Meeting Date:  
July 8, 2019

Location:  
2113 Ravenna Street

Request:  
Site Plan Application

Hudson Planning Commission	SITE PLAN REVIEW
Case No. 2019-485 January 11, 2020	July 2, 2019

## PROPOSED SITE PLANS

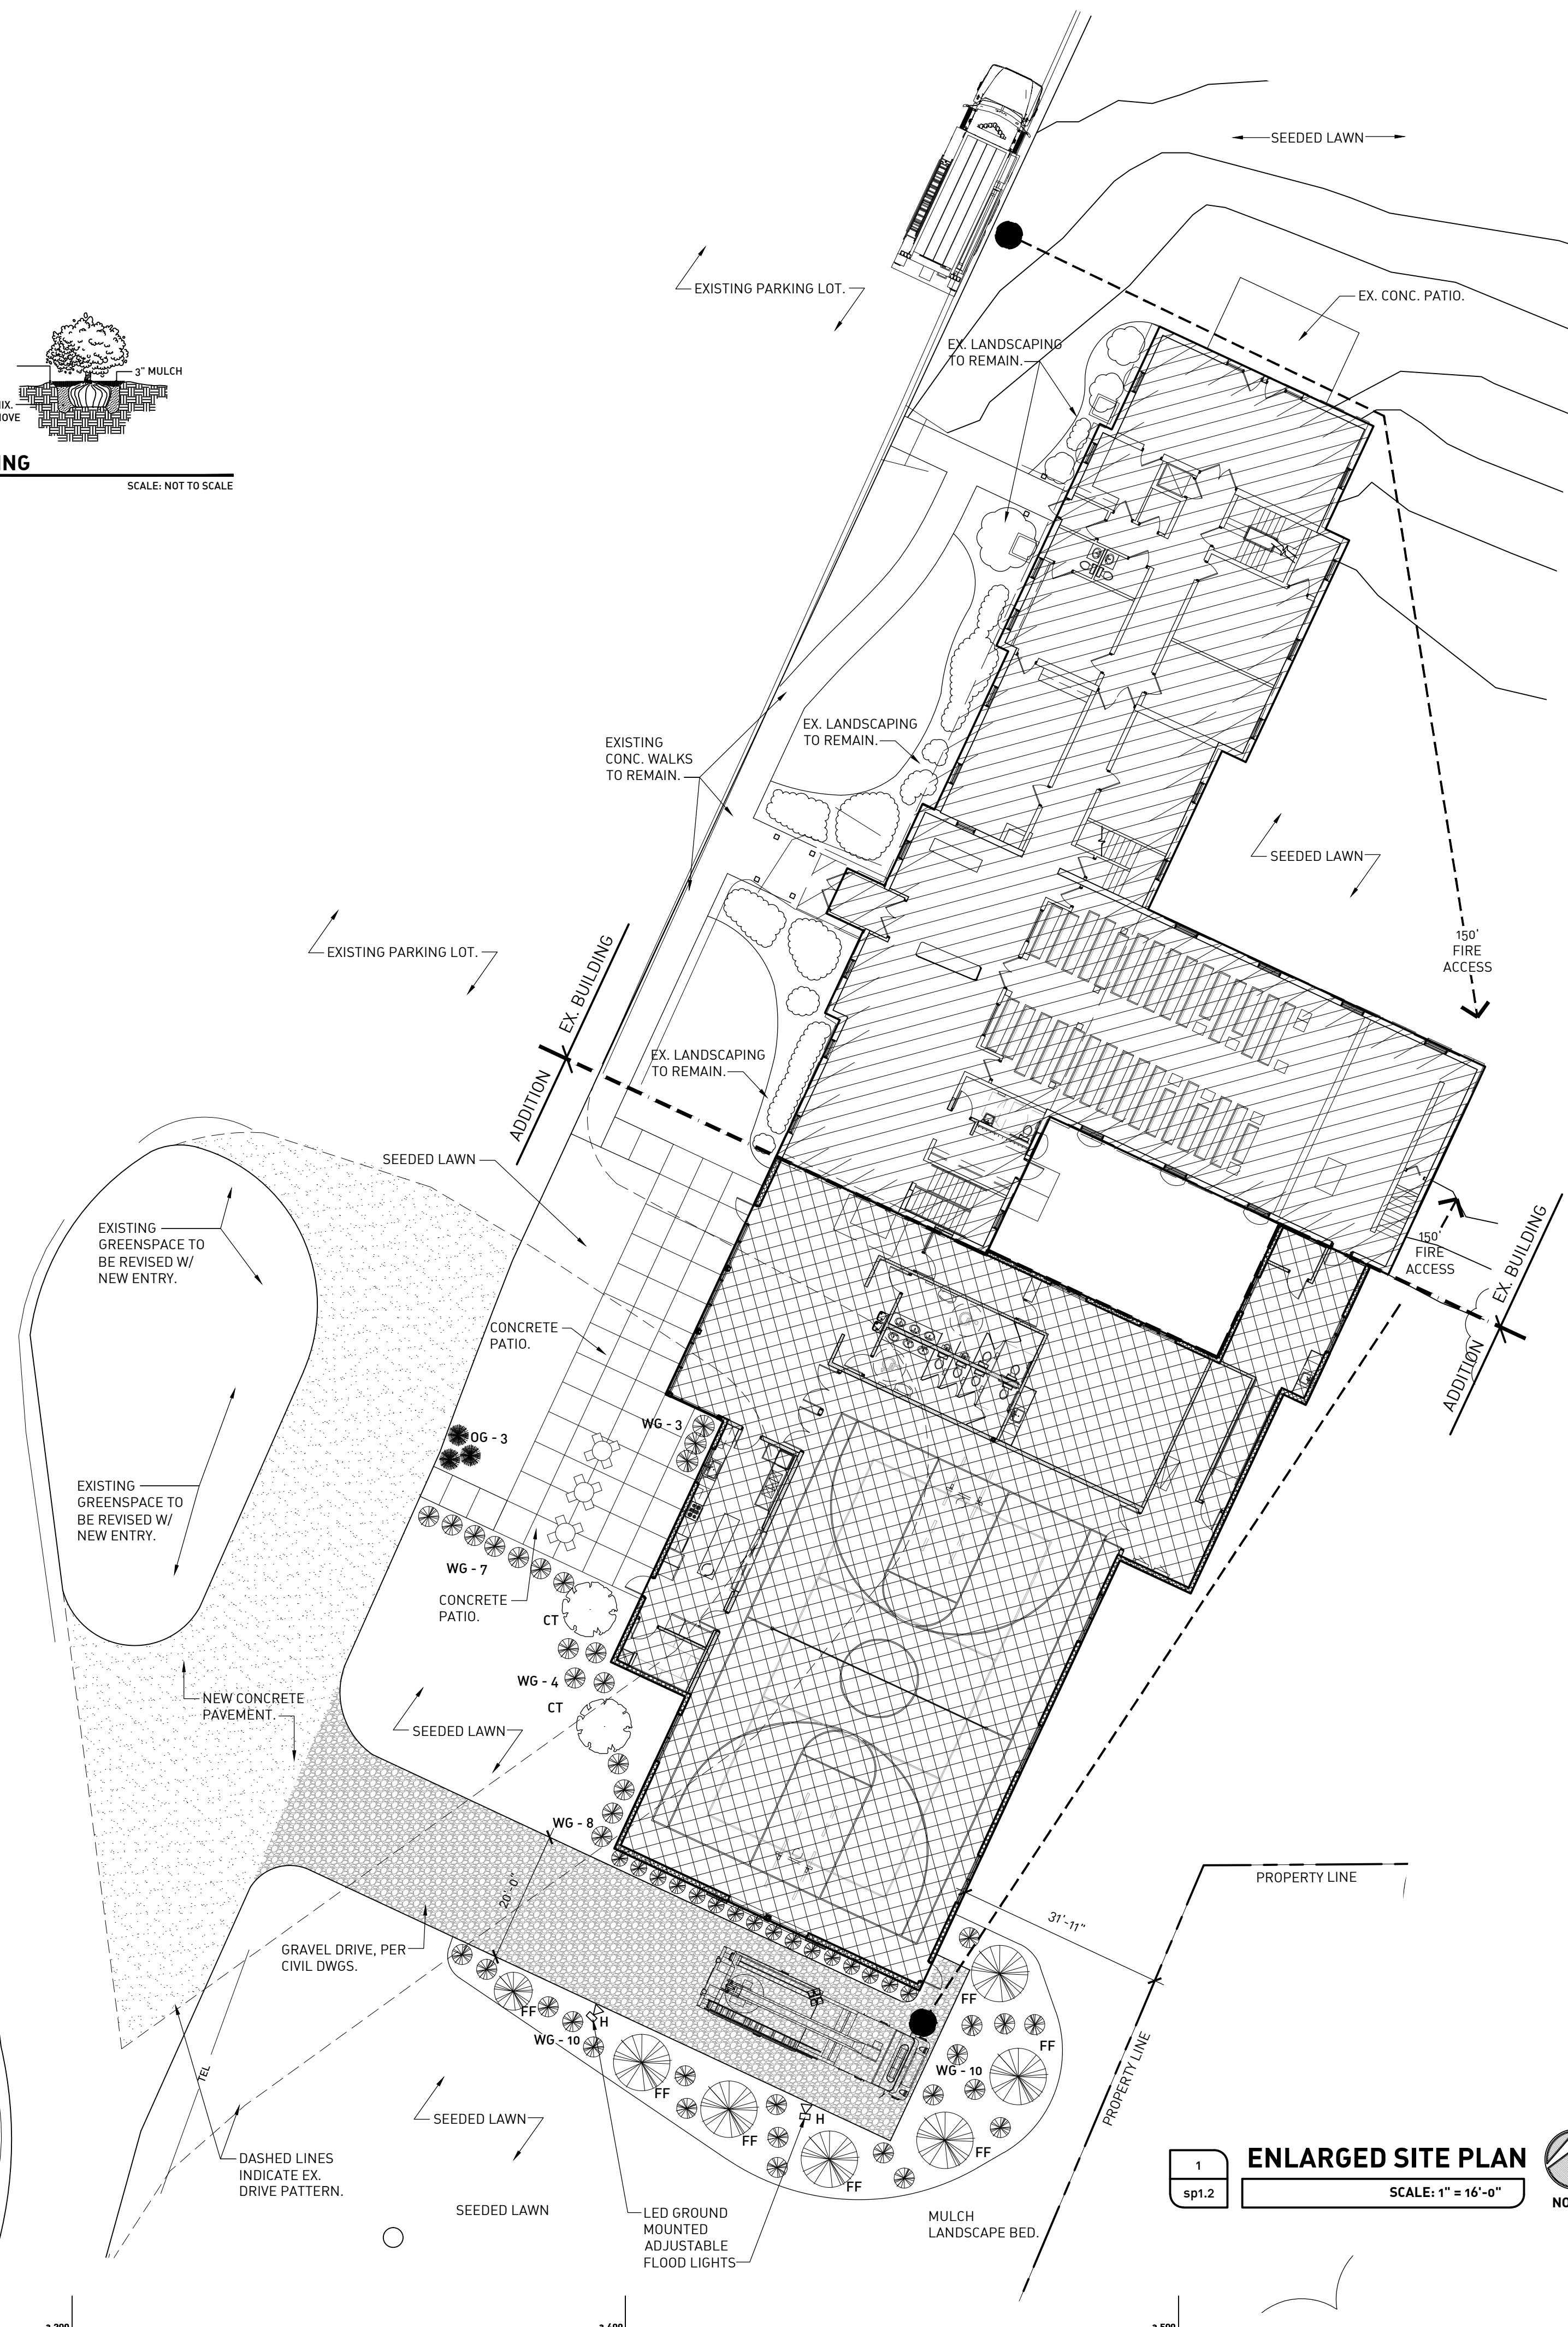
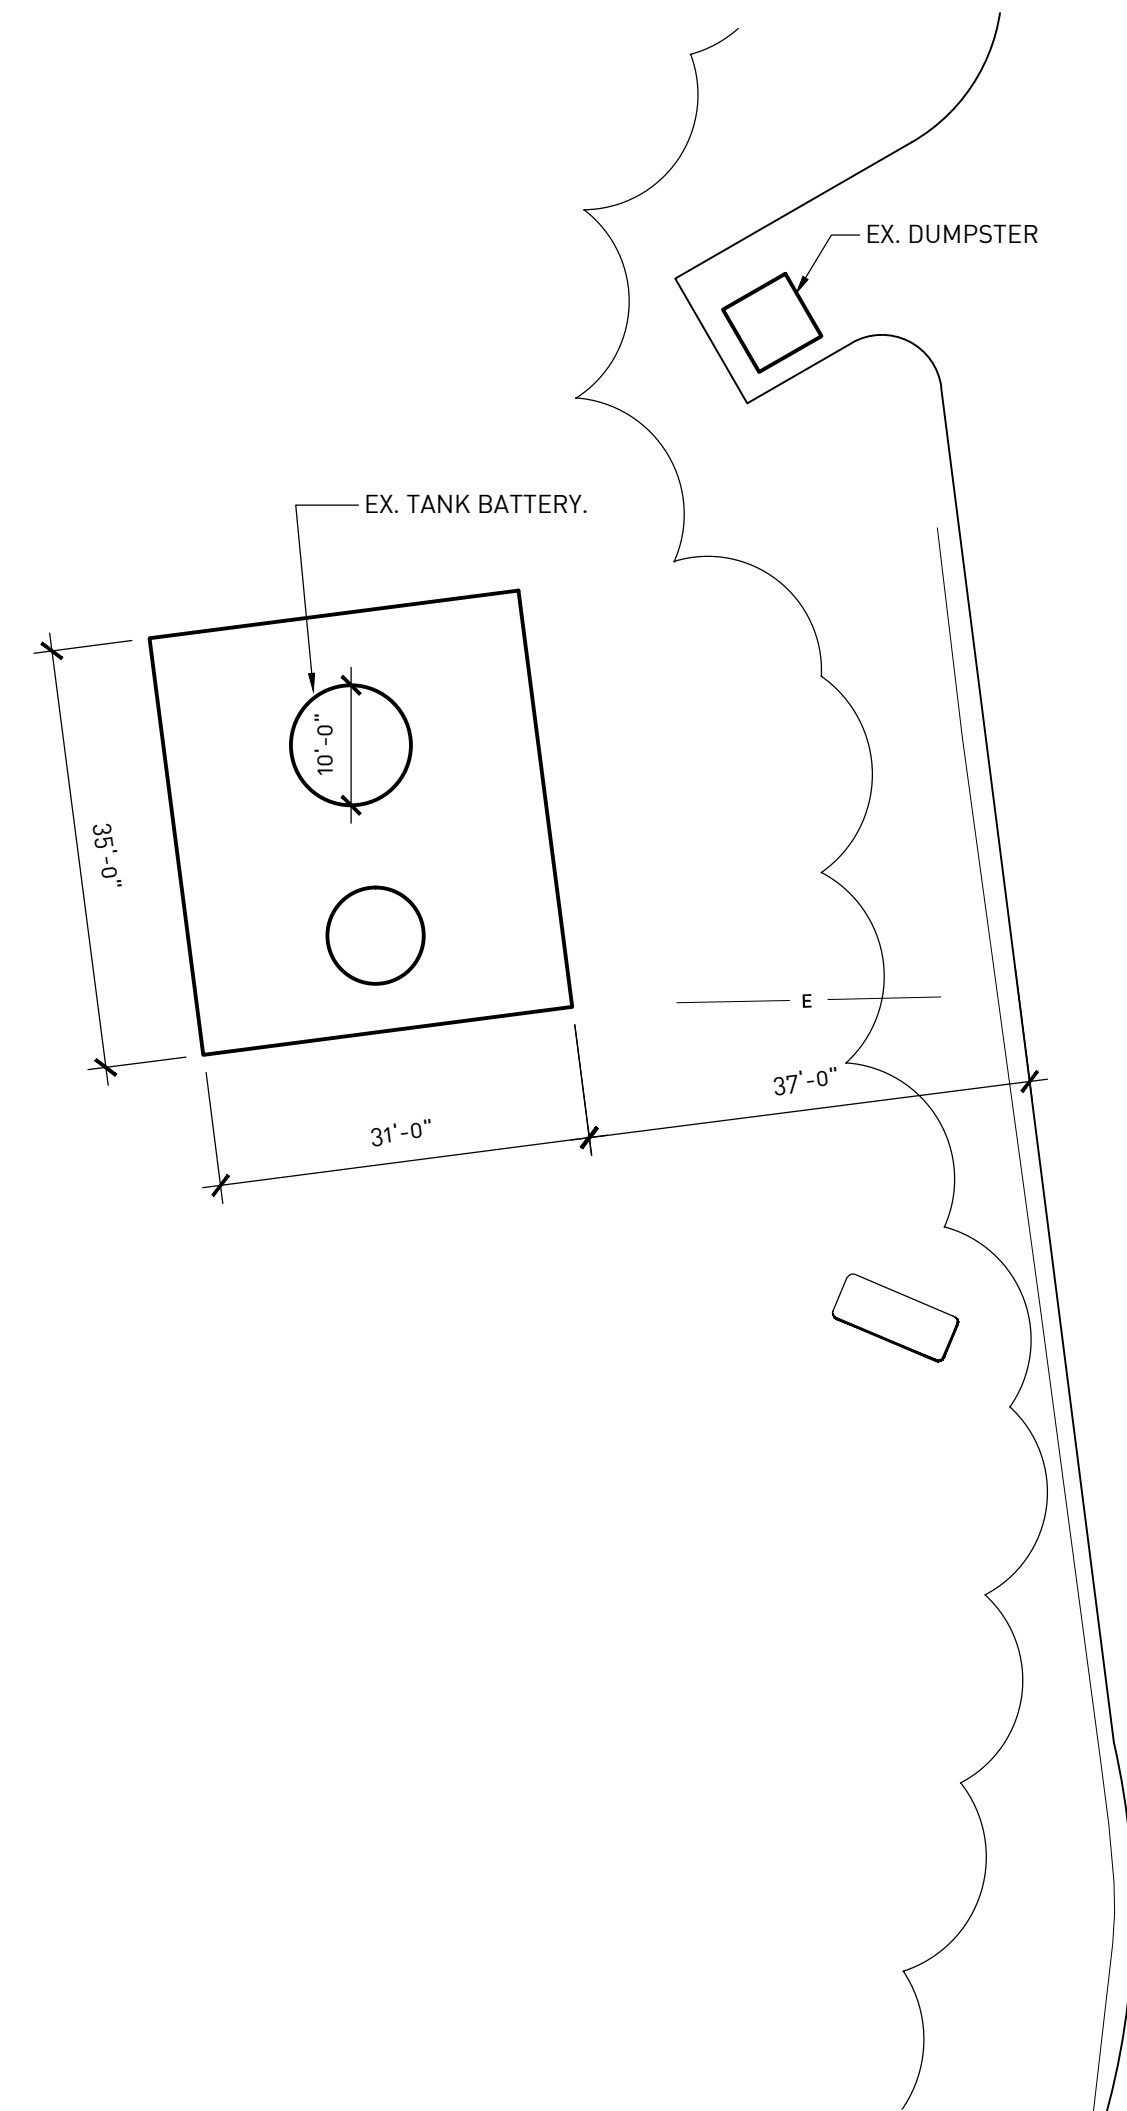
- ☐ **Landscaping** Bufferyard D (25 feet) is required. Add landscaping along east side of building addition and approximately 150' south of the playground. (condition 2)

1. Side yard buffer will include + 30' of seeded lawn and existing landscaping along property line. Proposed +/- 20' landscaping bed along southeast corner will be in addition to the seeded lawn and existing landscape along the property line.
2. No new dumpster enclosure proposed. Existing to remain.
3. Existing vegetation (wooded yard +/- 125') around the parking lot to remain to screen parking lot.
4. Civil drawing package is included to meet stormwater management requirements.
